AGENDA PORTLAND PLANNING BOARD MEETING

- i. Level III Site Plan and Subdivision; 144 State Street; Community Housing of Maine, Applicant. (estimated time 4:30 – 6:00 p.m.) The Planning Board will hold a workshop to consider a Level III Site Plan and Subdivision application to facilitate a 57-unit senior housing building and a 41-unit multifamily housing building at 73 and 91 Spring Street (formerly 144 State Street), along with associated site improvements. The subject property is 32,531 square feet in size and is zoned B-3 Downtown Business.

To: Brandon Mazer, Chair and Members of the Portland Planning Board
From: Caitlin Cameron, Urban Designer
Date: April 23, 2021
Re: Level III Site Plan, Subdivision, IZ Conditional Use – 73 and 91 Winter Street
Project #: PL-001371-2020
CBL: 045 C7001
Meeting Date: April 27, 2021

Figure 5 Proposed Site Plan (73 and 91 Winter Streets)

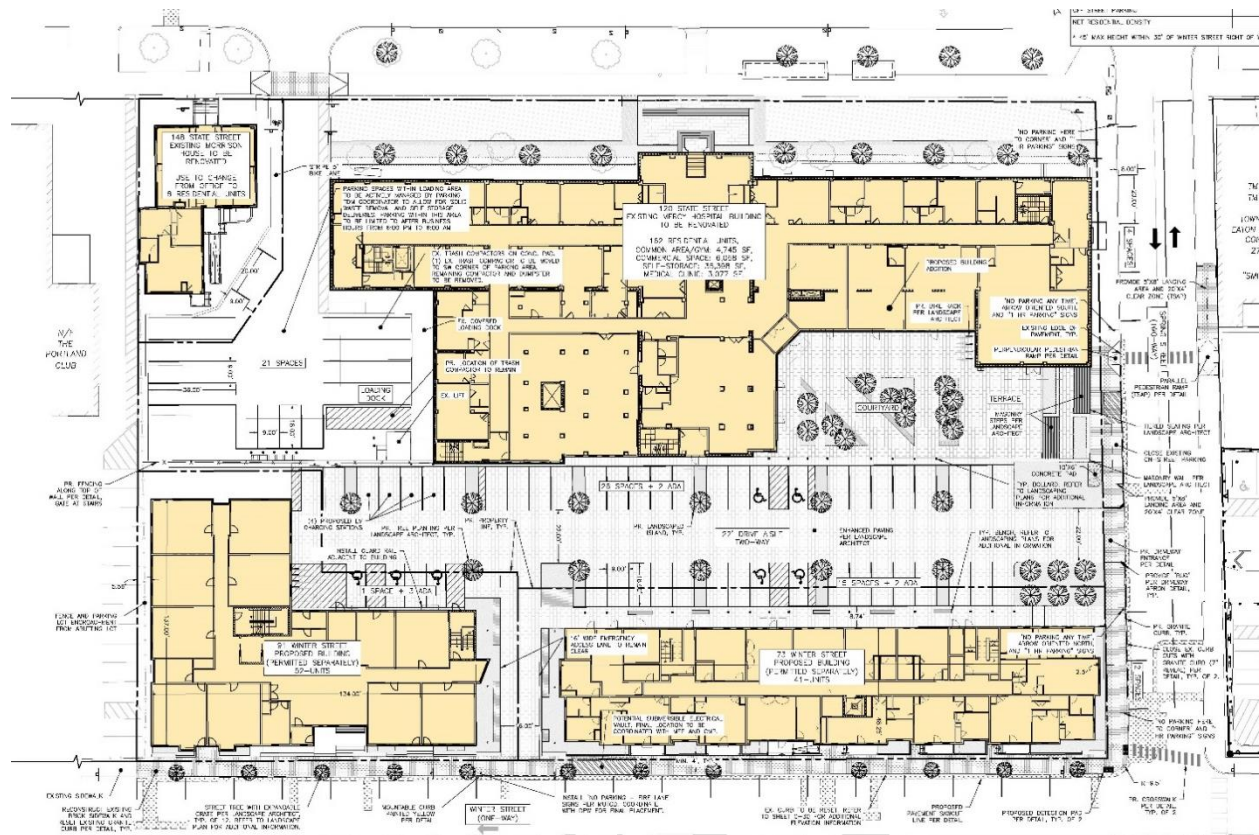
There are no curb cuts for the project (parking is accessed via Spring Street and evaluated with the 148 State application). An emergency vehicle access on Winter Street includes a mountable curb. Staff request more information regarding loading – the applicant proposes to use the existing loading dock area for many services – resident parking, loading, self-storage parking, and solid waste disposal. DPW Senior Engineer Mike Tremblay had the following comment ([Attachment 1](#)):

- *The Applicant proposes to shift the Spring Street centerline in order to provide parking along the development curb line, providing a net change of +6 spaces on Spring Street. The Applicant should consider the need for short-term loading and deliveries along Spring Street, as such activity may not necessarily take place within the site.*
- *While the City is amenable to a mountable curb at the emergency access lane, the City does not typically paint curbs. The signage locations are acceptable; however, the wording may not be correct. The Applicant should coordinate with DPW Traffic Operations to determine the correct, City-standard wording for these signs.*

- *The crosswalk across Winter Street at Spring Street is currently missing, and the street has worn down to the cobbles beneath. The surface is likely not accessible. The Applicant may be required to provide an accessible crossing across Winter Street. Historic Preservation should be consulted with regard to the cobblestones.*
- *The proposed mid-block crosswalk on Winter Street is located within 200 feet of two other crosswalks, at Winter Street and State Street. It may be unnecessary. The Applicant and DPW should discuss to determine whether it should remain in the future. The crosswalk's ramps interrupt pedestrian flow along the sidewalk on Spring Street; see below comment.*

- *The pedestrian ramp along the north side Spring Street does not appear to provide an ADA-compliant landing at the top of the ramp. A parallel ramp may be needed, if it is determined that the mid-block crossing should remain (see above comment)*

- *Sidewalks on Winter Street will be required to be reconstructed as part of the 73 and 91 Winter Street projects. The site plan calls for new granite curb at an existing curb cut, and a mountable curb at locations along Winter Street. The sidewalk reconstruction work should be coordinated with this curb work along Winter Street.*

- *The site plan appears to show granite curb extending through the brick sidewalk at the Spring Street driveway. This does not meet the City's standard. Granite should not be extended through the sidewalk; the brick sidewalk should continue uninterrupted through the driveway.*

- *Electrical vaults along the Winter Street sidewalk and within Spring Street should be treated as fixed objects with rigid elevations; as such, any discrepancies between the field conditions and the plans may create challenges along the narrow Winter Street and Spring Street sidewalks. Care should be taken to set transformers at the specified elevations and ensure that other site features are compatible with the finished grade of these transformers. If at all possible, vaults should be moved into the site. The Applicant shall be responsible for achieving ADA compliance along their frontage. Finished conditions that do not comply with ADA due to vault elevations shall not be accepted.*
